This application is for the following scope of amendments:

1. Clarify internal contradictions in CofA pertaining to stair bulkhead to address Notice of Violation; application is for as-built bulkhead to remain
2. Add a safety rail at north end of roof, not visible from street
3. Add an enclosure for fresh air intake at front areaway

Also shown: documentation of corrective work to address Notice of Violation

**1. ENLARGED DETAIL AT BULKHEAD**

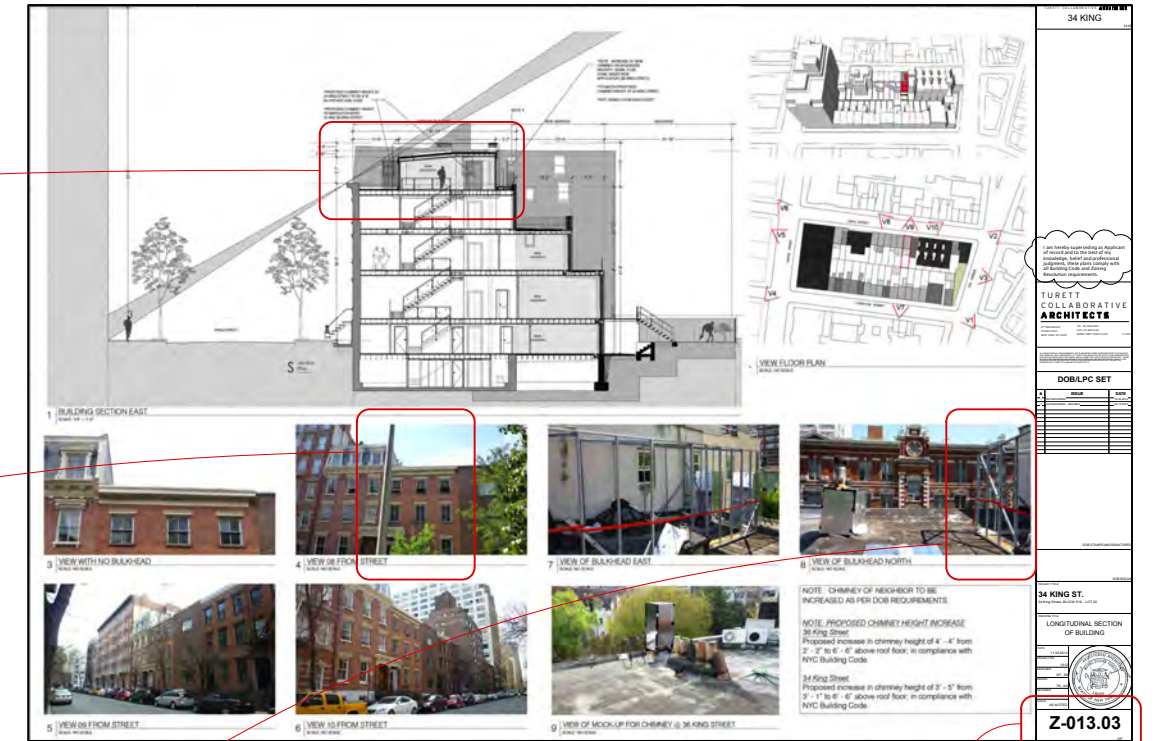
Showing section sloping down to the north. Note contradiction with photograph of mock up (this sheet) showing slope down to the west, and contradiction with building section at sheet Z-012 and detail section at sheet A-811 showing flat roof

**3. ENLARGED DETAIL AT PHOTOGRAPH OF MOCK UP**

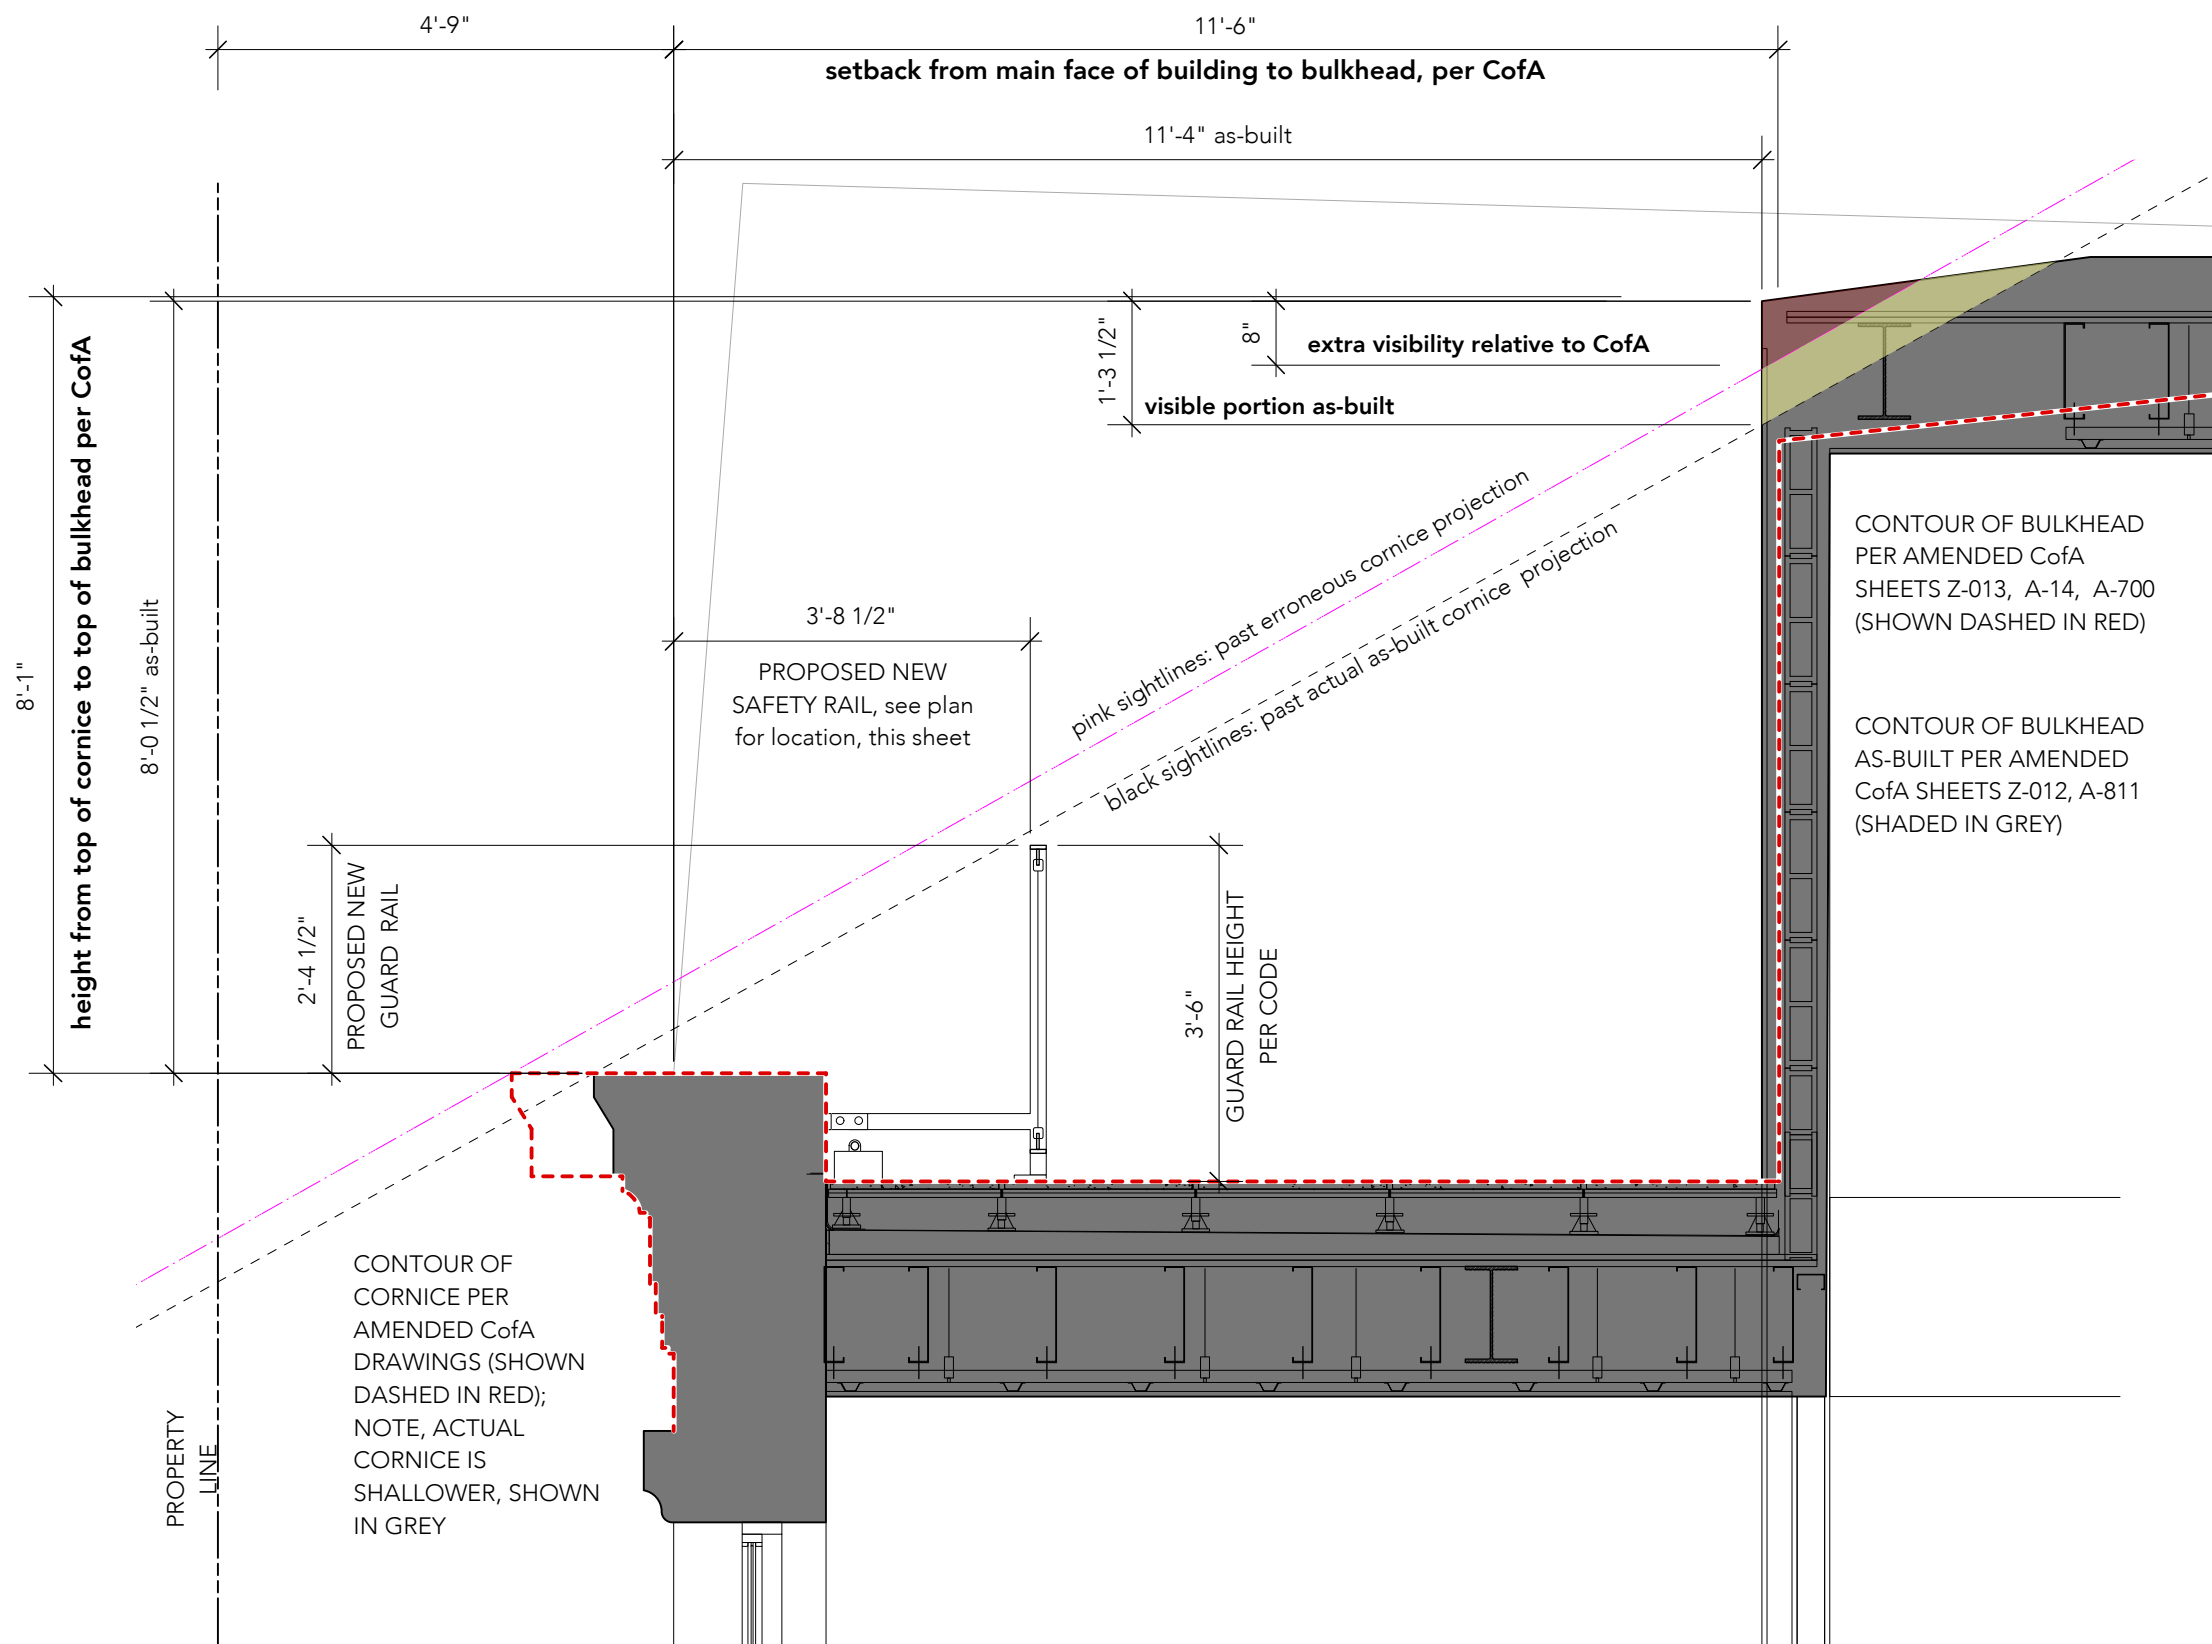
Showing slope down to the west; this is different than shown at building section on this sheet, and different than shown on detail sections of approved drawings

note structure sloping down to the west, dashed in blue; level line dashed in red for clarity

1. ENLARGED ROOF SECTION  
(scale: 1/2" = 1'-0")

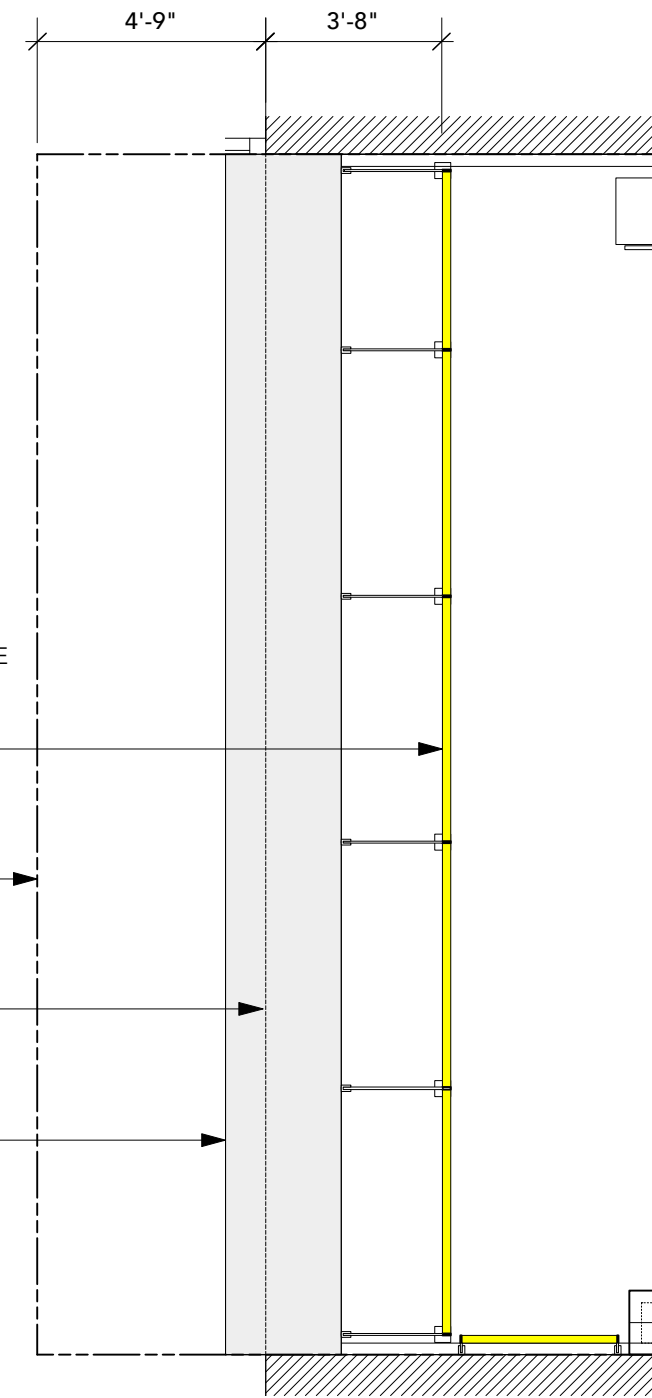
The language of the CofA referenced the setback and height for the approved bulkhead; the assembly as-built closely follows these dimensions (see detail section at sheet A-2, previous in this application.)

2. PARTIAL ROOF PLAN, SHOWING PROPOSED GUARD RAIL  
(scale: 1/4" = 1'-0")

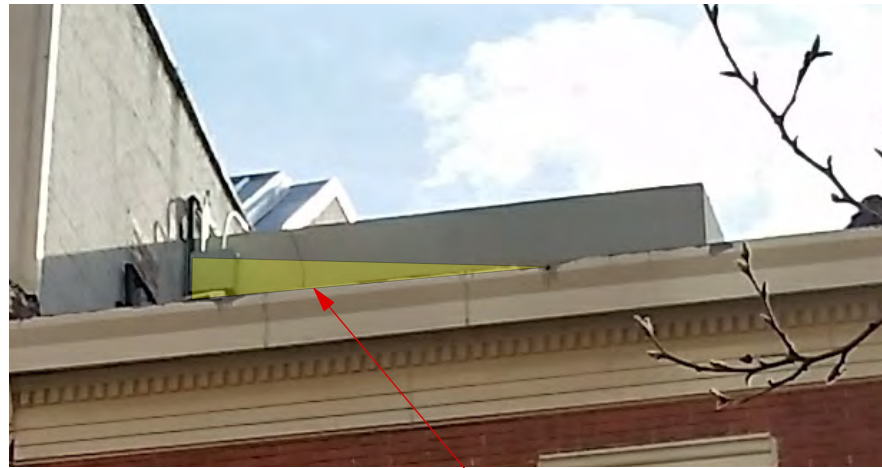
- C.** Approved drawings show a guard rail near the center of the roof; DoB requires fall protection near the north edge. (see (C), this sheet). We respectfully request permission to build a guard rail set back 3'-8" min. from the face of building, situated so as to be not visible from the street. Detail to match approved guard rail for this site at south end and at rear yard, per CofA.

1. PHOTO AT BULKHEAD, FACING SOUTHEAST (compared to original CofA contour)

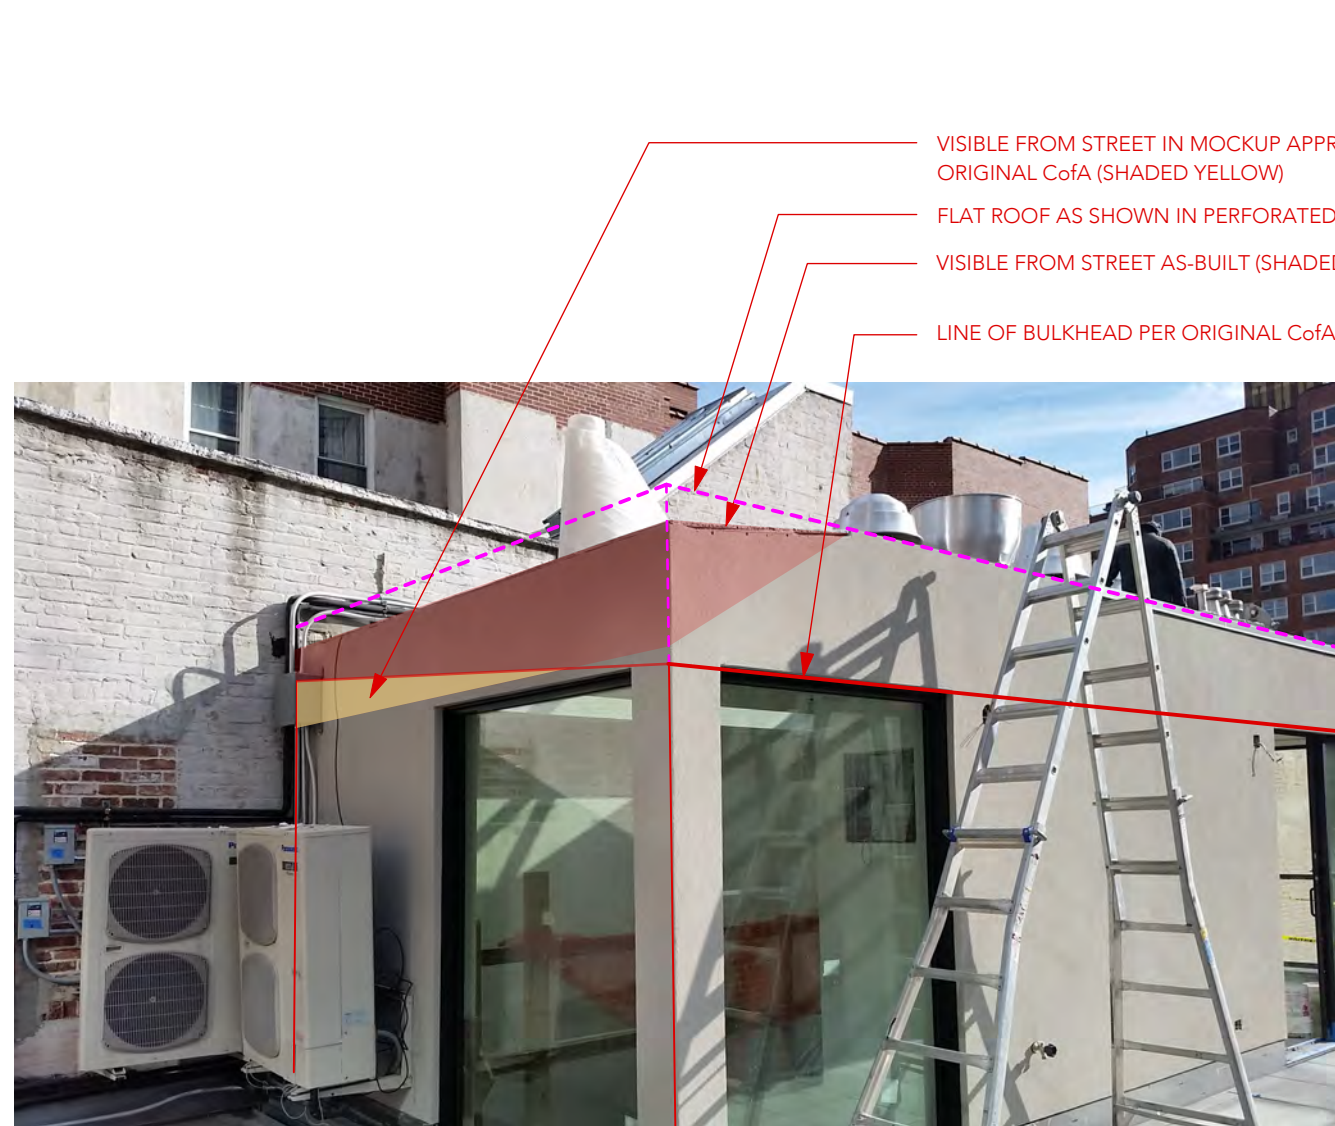
The presentation leading to the original CofA, dated 04/01/14 (under a different design applicant) incorporated photodocumentation of a mockup of a bulkhead sloping down to the west (illustrated above in solid red line), and showing the area in yellow visible from the street. This was deemed "minimally visible" in the CofA.

Additional support documentation (sections and elevations throughout the filed drawings) included contradictory information, including a flat-roofed bulkhead (dashed in pink, above).

2. PHOTO AT BULKHEAD, FACING SOUTHEAST (compared to amended CofA contour)

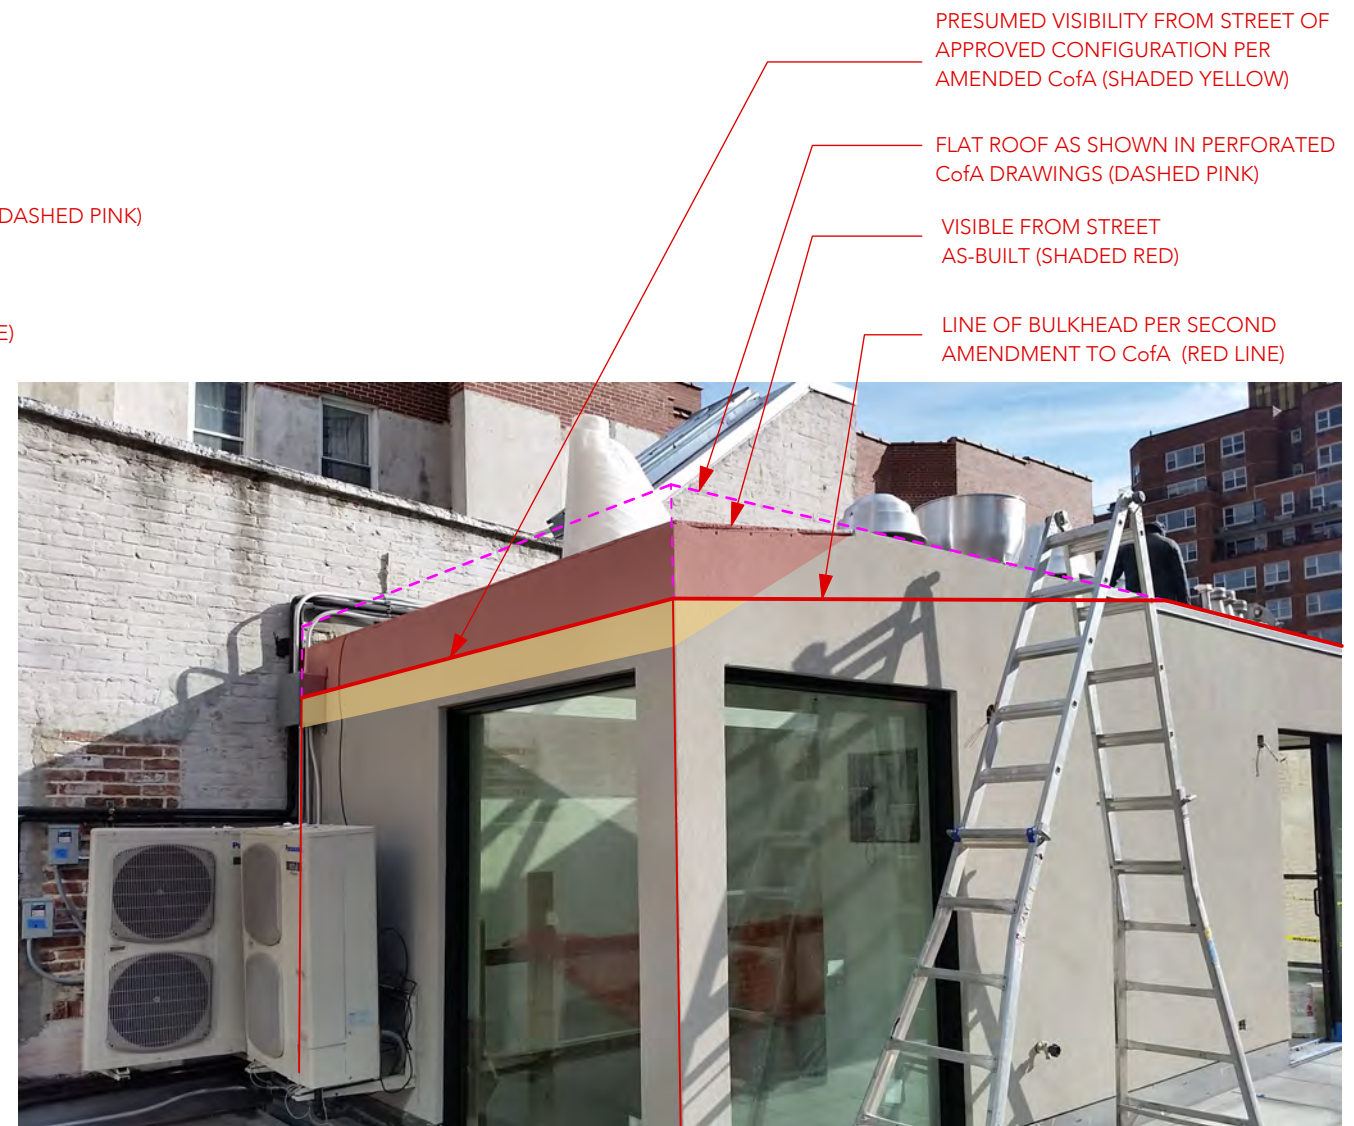
The first amendment to the CofA (under a different design applicant) incorporated a modified bulkhead shape, sloping down to the north, as illustrated above (solid red line). Photodocumentation on amended sheet Z-013 appears to show the earlier mock-up (sloping to the west). However, we surmise and calculate that the amended configuration would have been "minimally visible".

Sections and elevations showing the flat-topped bulkhead (dashed in pink, above) remained in the approved, amended drawings (eg. sheets Z-012, A-600, A-601, A-811)
